PROJECT: Land to the north-west of Westhide, Herefordshire, HR1 3RQ (Ref: P214619/F)

CLIENT: Ersun (Westhide SPV) Ltd

Date: 24th October 2022

Landscape and Visual Impact Assessment Addendum: Amendments to Landscape Proposals

Drawing Number: 3352_L_GA_0_01

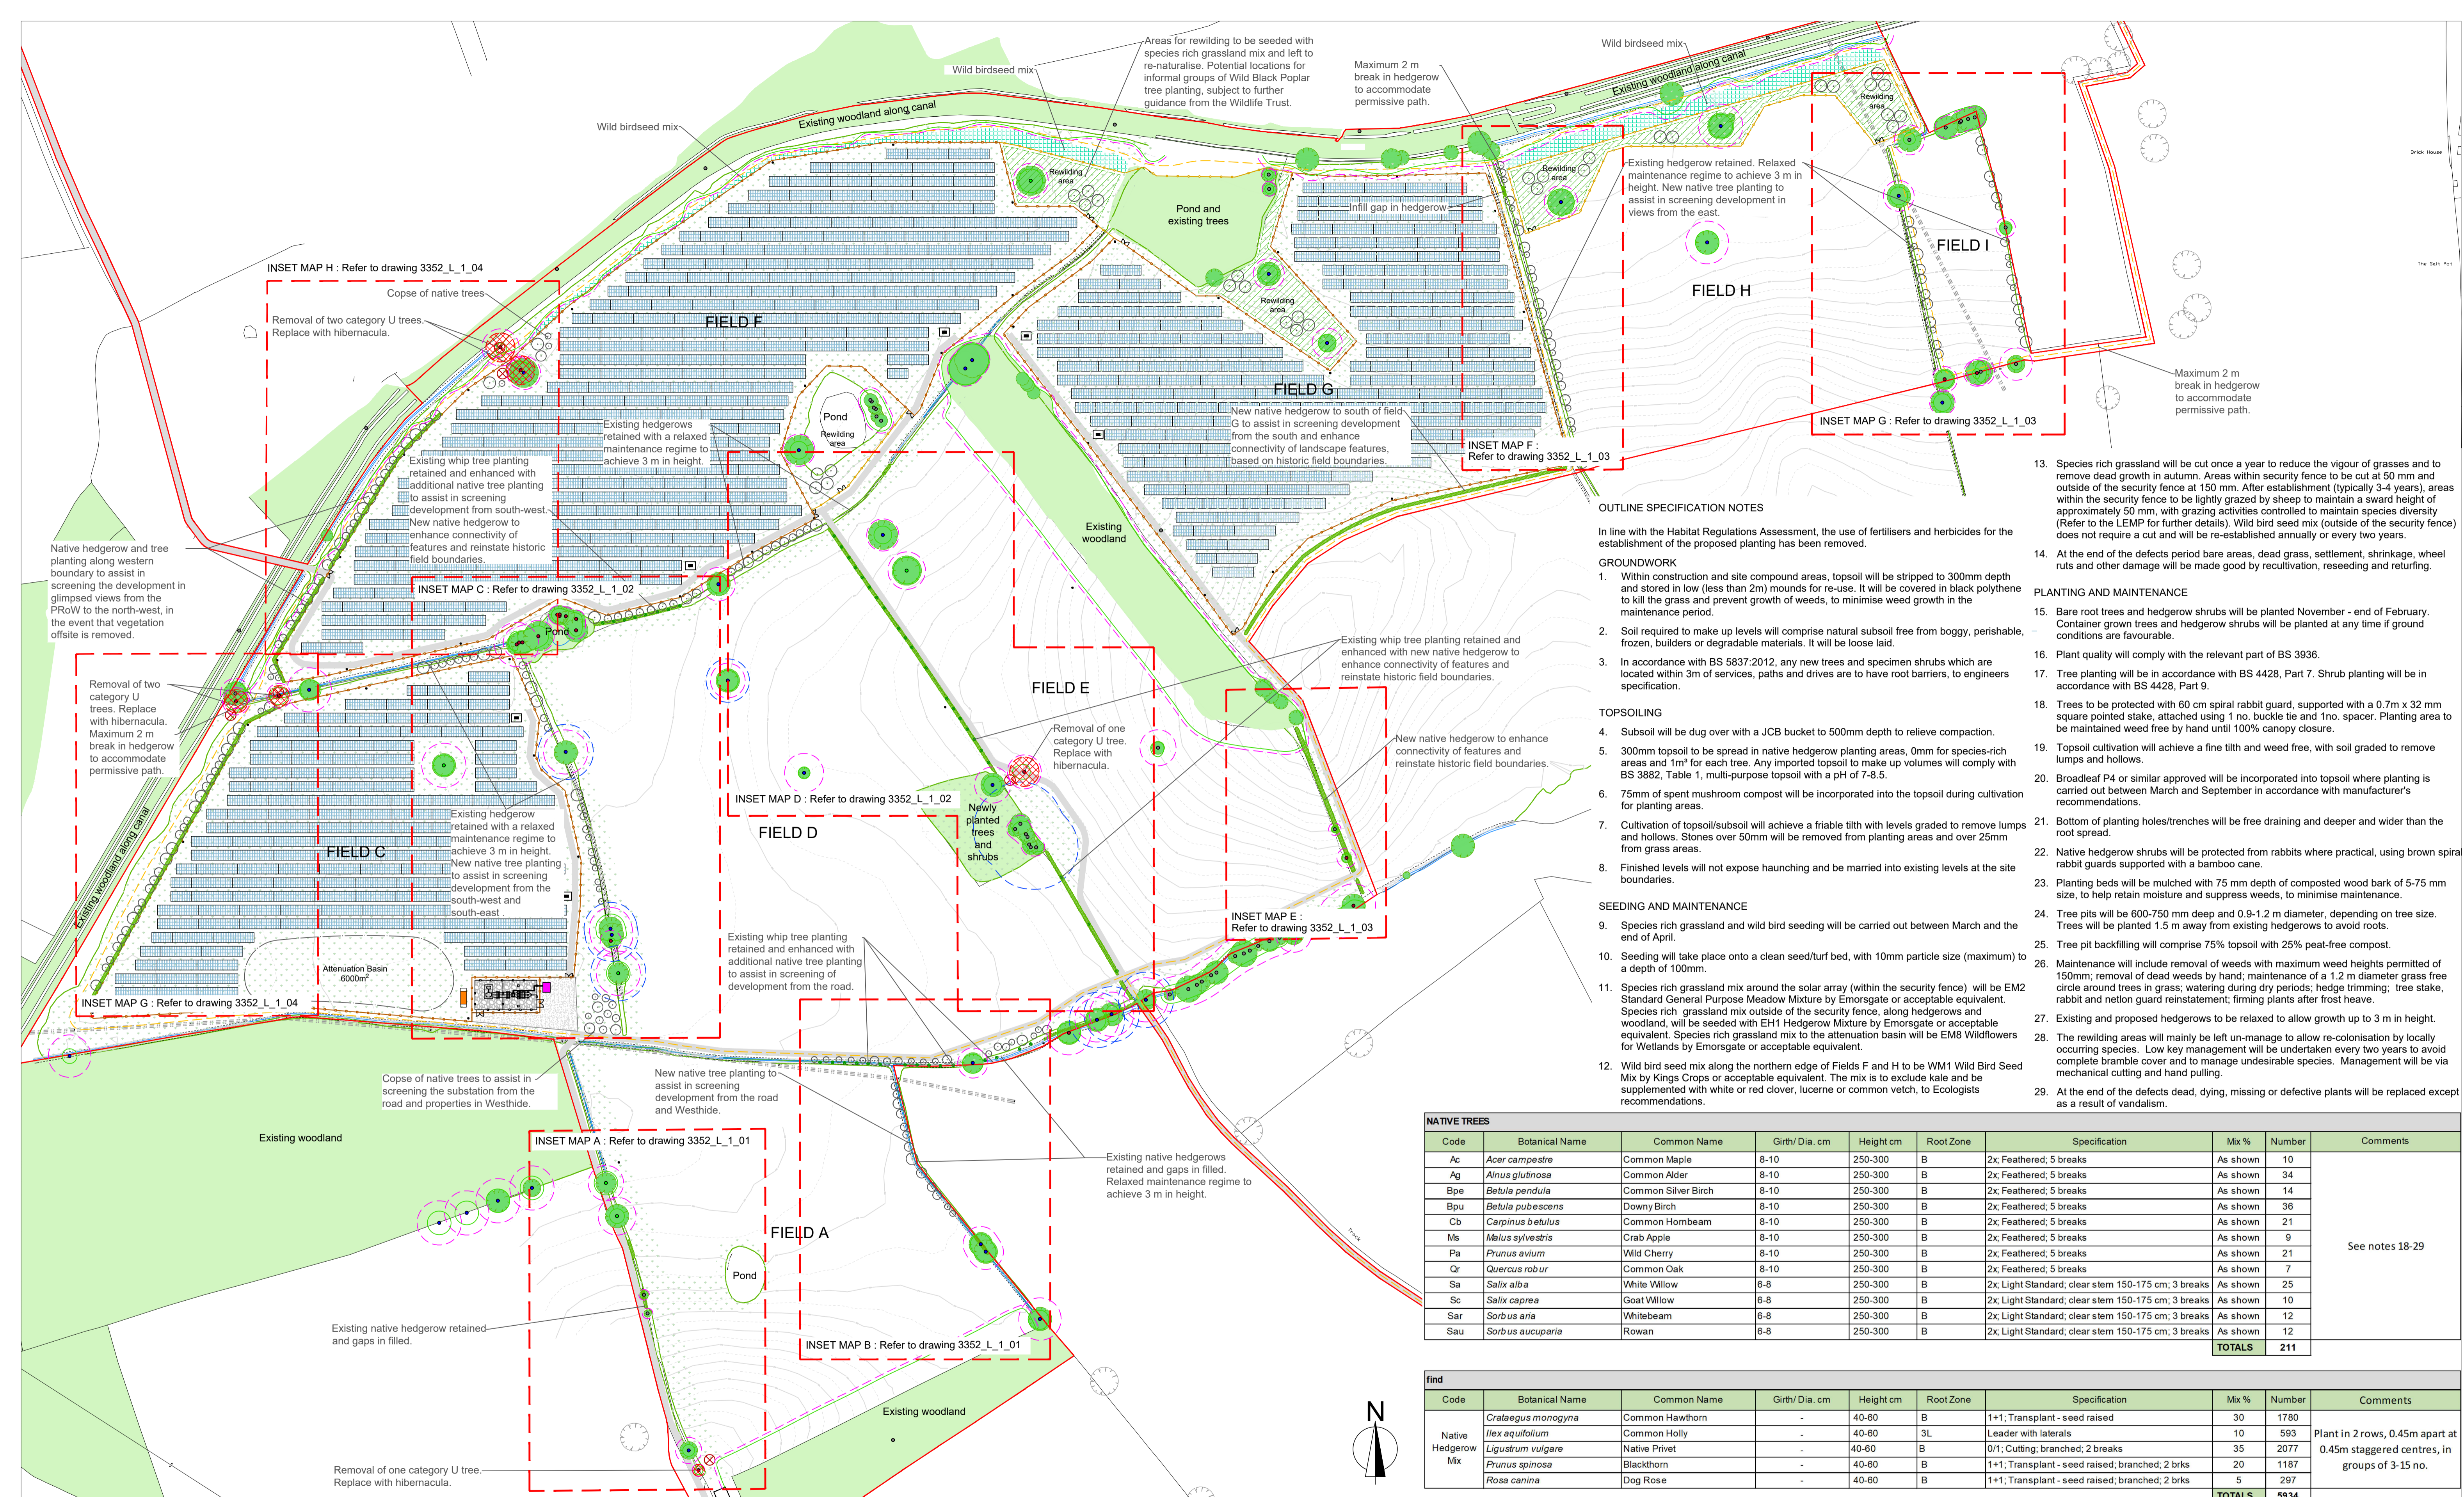
Based on further feedback from the Herefordshire Council in regards to the use of Best and Most Versatile (BMV) land for solar PV instead of food crops, it was agreed that panels would be removed from those fields that consisted predominantly of higher-grade agricultural land. Panels have therefore been removed from fields A, D, E, H and I. Proposed mitigation measures for the scheme have been amended accordingly to reflect the reduction in the extent of the array, which are shown on the accompanying drawings and as outlined below:

An attenuation basin (6000m² in area) has been added to Field C, positioned along the southern boundary. A species rich grassland seed mix is proposed within the basin which is tolerant of being seasonally wet.

Status: PLANNING	Drawn: JH	Checked: LF
Scale: 1:2000@A1	Date: 03.12.2021	Approved: AS
Drawing Number: 3352_L_GA_0_02	Rev: E

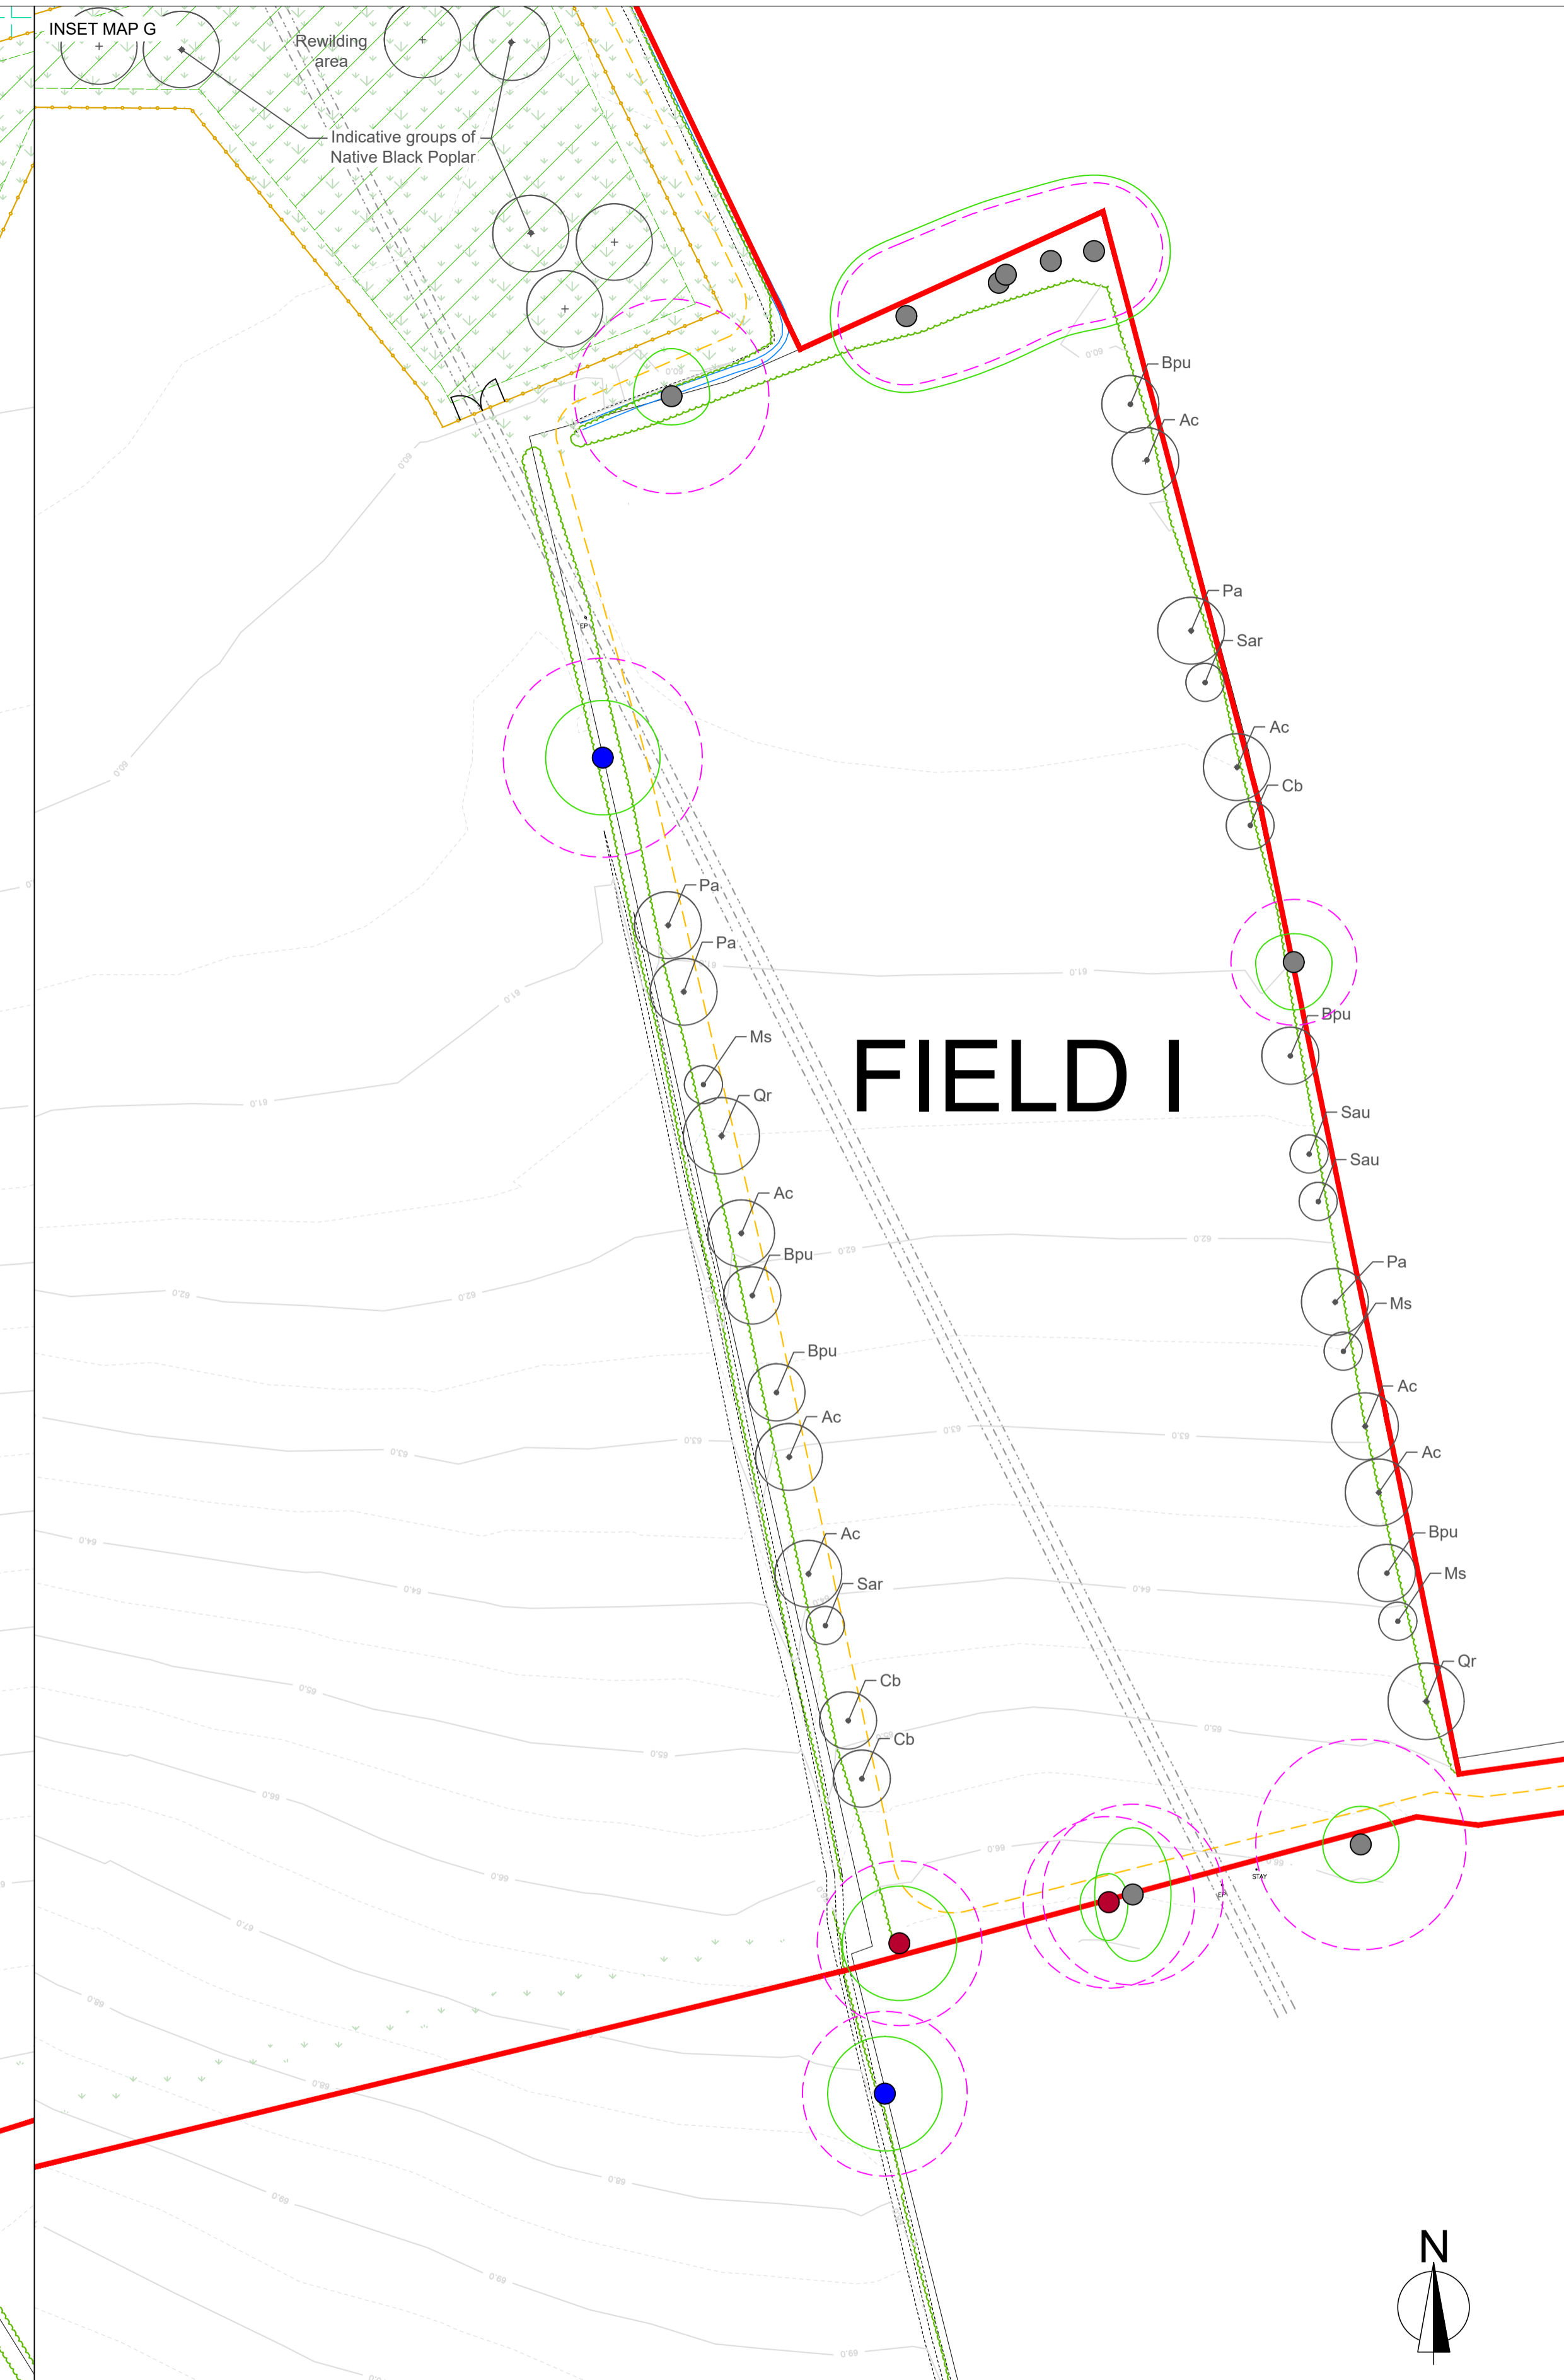
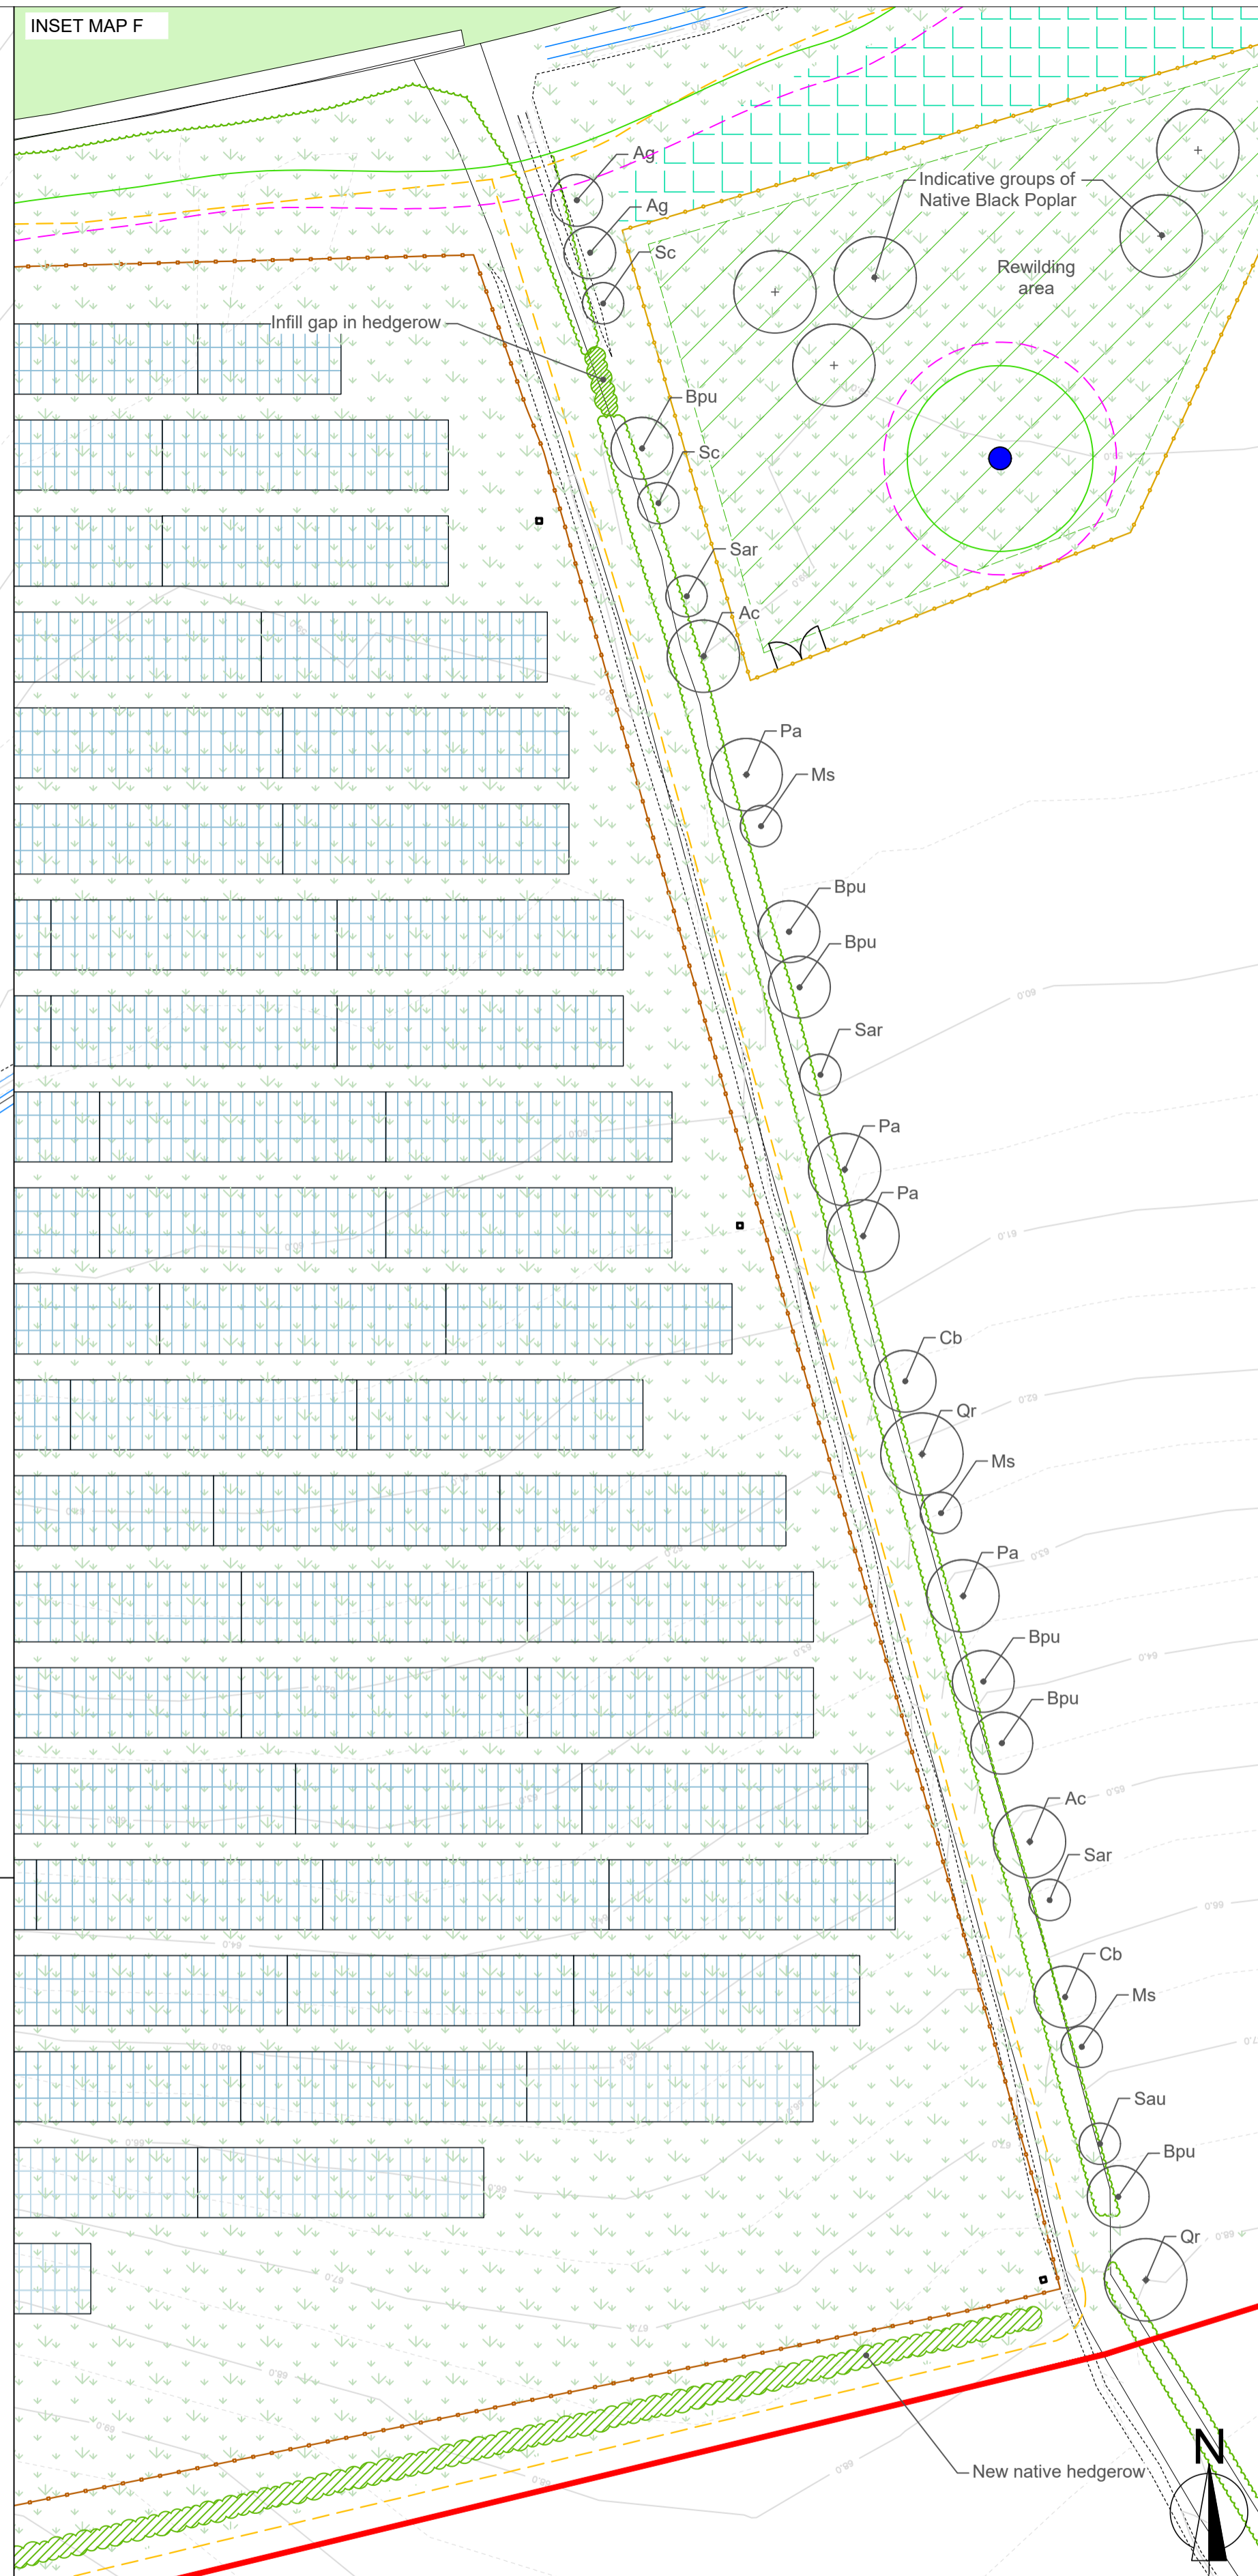
Fields A, D and E:

Proposed tree planting along the western boundary of Field A has been removed, as there is no longer a need to filter views of this field from the west. Tree planting to the eastern boundary of Field A and southern boundary of Field D has been retained to create a layering of vegetation, in combination with tree planting along the western and northern boundary of Field D. This is to assist in filtering views of the development in Fields C and F when views from the road to the south and from Westhide to the south-west.

Along the boundary between Fields D and E, the previously proposed hedgerow alongside the existing tree planting has been retained as part of the scheme to reinstate the historic field boundary and to enhance connectivity of natural features, including the isolated woodland block along this boundary. Similarly, the hedgerow has been retained along the eastern boundary of

Field E, restoring the historic field boundary and connecting the woodland belt with the vegetation along the stream to the south. Any additional tree planting along these boundaries have been removed as there is no longer a need to filter views of the development in Field E from viewpoints to the west.

Fields H and I:

The previously proposed tree planting along the eastern and western boundaries of Field I have been retained. The density of tree planting has been reduced slightly as additional tree planting is proposed along the eastern boundary of Field G which will contribute to the layering of vegetation, filtering views of the development in Field G when viewed from the road and properties to the east. Proposed hedgerow across Field H has been removed to retain a larger Field, which will be beneficial to ongoing agricultural uses.
